OAKS OF FOWL RIVER SUBDIVISION, **RESUBDIVISION OF**

APPLICATION NUMBER 12 DATE September 7, 2017

DETAIL SITE PLAN

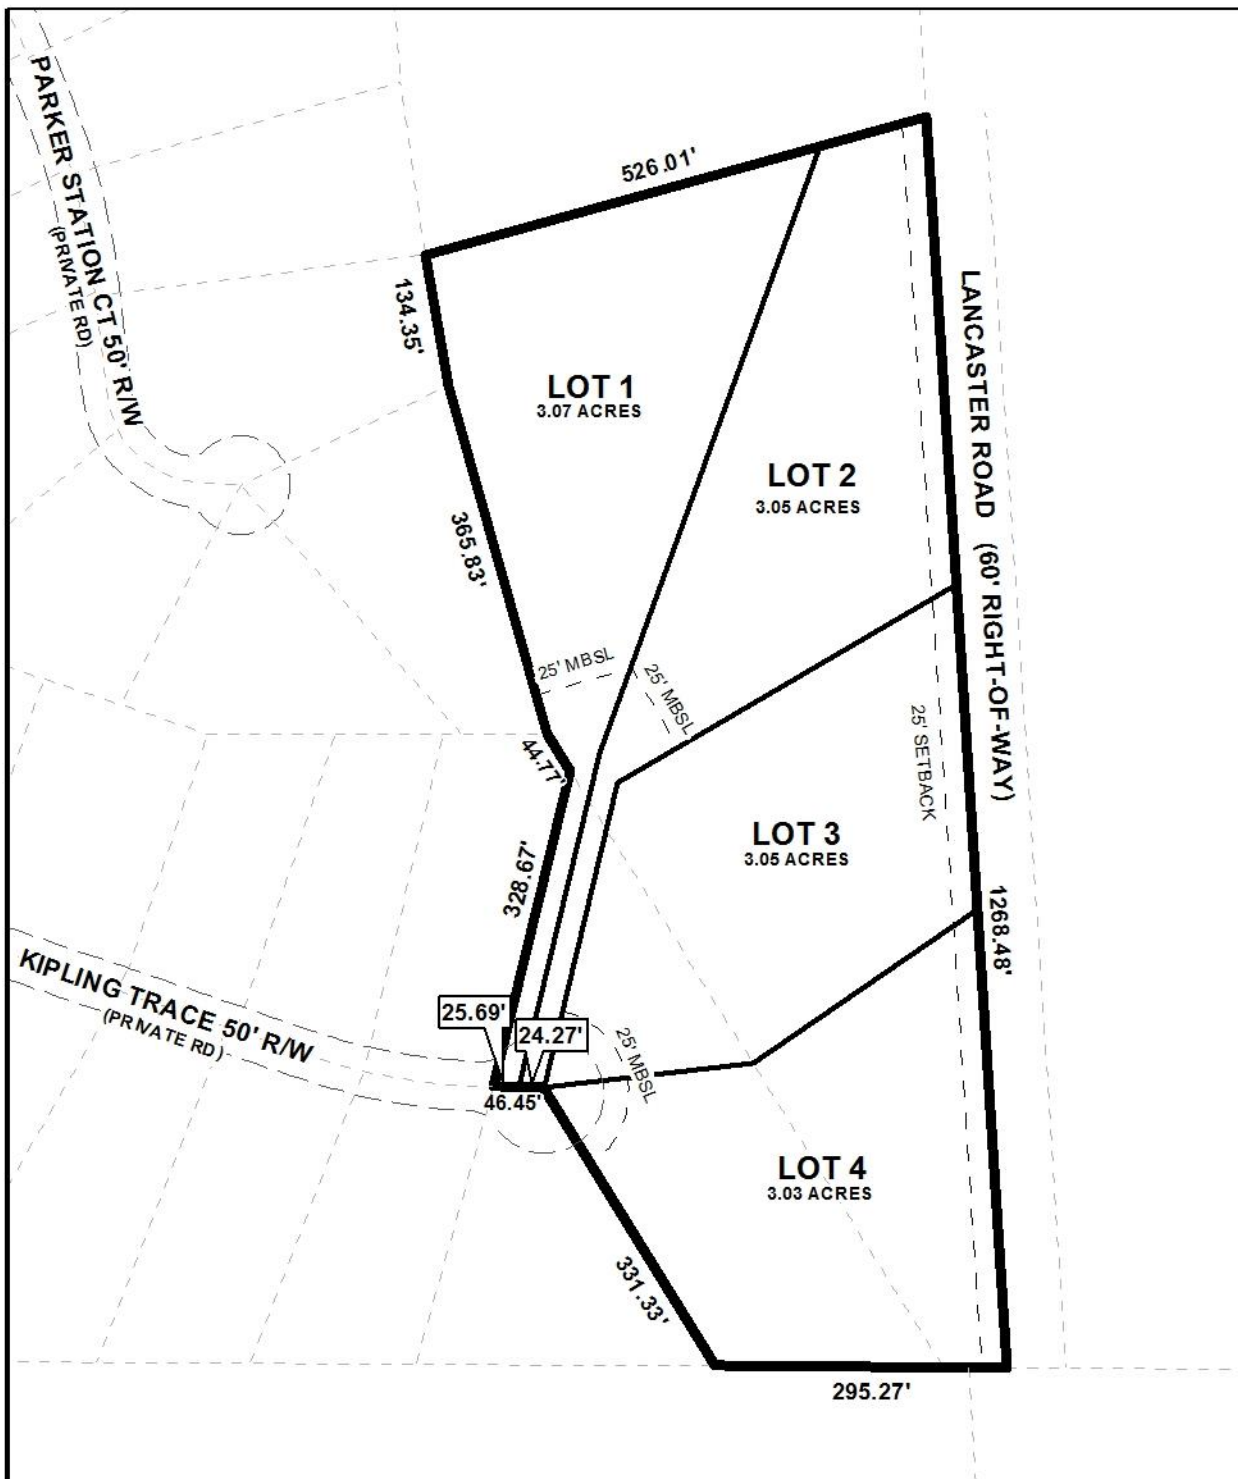
The purpose of this application is to create four legal lots of record from two legal lots and one metes-and-bounds parcel. The applicant proposes to create four (4) new lots from portions of the existing lots (Lots 4 and 5), and an undeveloped area that is located to the North, South, and East of the proposed lots extending to an undeveloped portion of Lancaster Road. The remaining undeveloped area is not shown in its entirety on the preliminary plat, and should be revised to depict the remaining undeveloped area as a "Future Development" area or as a phased development.

It should be noted that the proposed lot configurations create irregular shaped lots, specifically Lots 1 and 2. Lots 1 and 2 create a "panhandle" or "flag lot" shape, and is generally not allowed, but permitted only in those locations where varied and irregularly shaped lot designs are common and the informality of design is consistent with other lots in the vicinity; or where unusual circumstances such as an odd shaped lot exists; or separate disparate uses exist on a single lot; or where there are natural or pre-existing man-made barriers which may cause an undue hardship on the land owner; or in the case of a family division. Currently, there are no similarly-shaped lots within the immediate vicinity of the proposed subject lots.

The 25-foot minimum building setback line is depicted on the preliminary plat for each proposed lot along both Kipling Trace and the undeveloped portion of Lancaster Road, and should be retained on the Final Plat, if approved,.

The lot size information is depicted in both square feet and in acres on the preliminary plat and should be retained on the Final Plat, if approved.

As a means of access management, a note should be placed on the Final Plat, if approved, stating that the each lot is limited to one curb cut to Kipling Trace, with any changes to the size, design and location of the curb-cut to be approved by Mobile County Engineering and conform to AASHTO standards. Access to Lancaster Road is denied.

- 1) There are no other flag lots in the vicinity, and thus, does not comply with Section V.D.1. of the Subdivision Regulations.
